UNITED STATES PATENT AND TRADEMARK OFFICE

10/552,027

Office Action Summary	Application No. 10/552,027	Applicant(s) ROLF, THEODORUS SUIBERTUS ANTHONIUS	
	Examiner AMIR KLAYMAN	Art Unit 3711

DETAILED ACTION

Examiner's markings

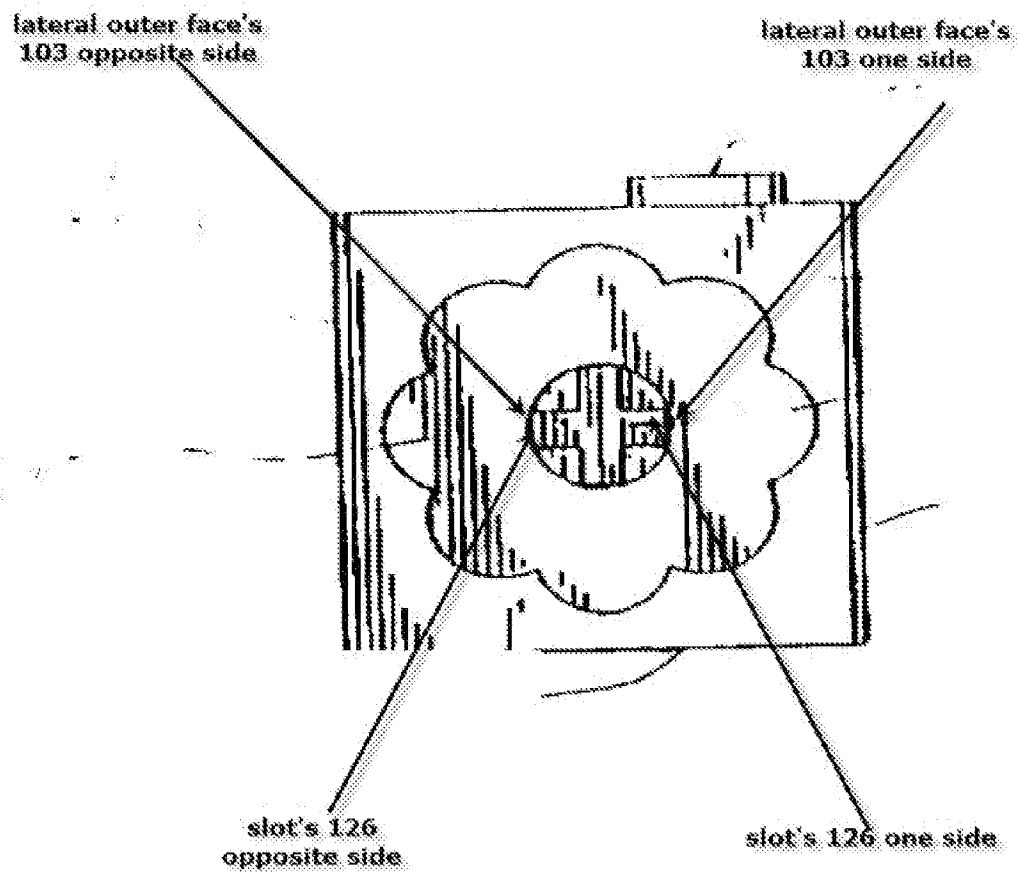
6. Claim 26 is rejected under 35 U.S.C. 103(a) as being unpatentable over Cyrus et al US 6,129,605 as applied to claim 17 above, and further in view of Glynn US 5,725,411.

As cited in the previous office action (which is incorporate herein), Cyrus does not disclose at lest one slots penetrating a lateral outer face for holding edges of construction devices. Glynn was added to show a block (100) having lateral outer face (103) with at least one penetrating slot (construed as recessed connection means (126)) configured to hold edge of construction beam (105) as best seen in figs 6a-6h and discussed in column 4, line 50 to column 5, line 42 (see the examiner rational to modified Cyrus with the teaching of Glynn as discussed in section 4, pages 10-11, in the previous office action). With respect to the added limitations "...at least one slot penetrating the lateral outer face from one side of the lateral outer face to an opposite side....", the examiner will marked Glynn's block to show that slot (126) is penetrating lateral outer face (103) from one side of the lateral outer face (construed as the right side of slot (126) positioned on the right side of outer face (103)) to an opposite side (construed as the left side of slot (126) positioned on the left side of outer face (103)).
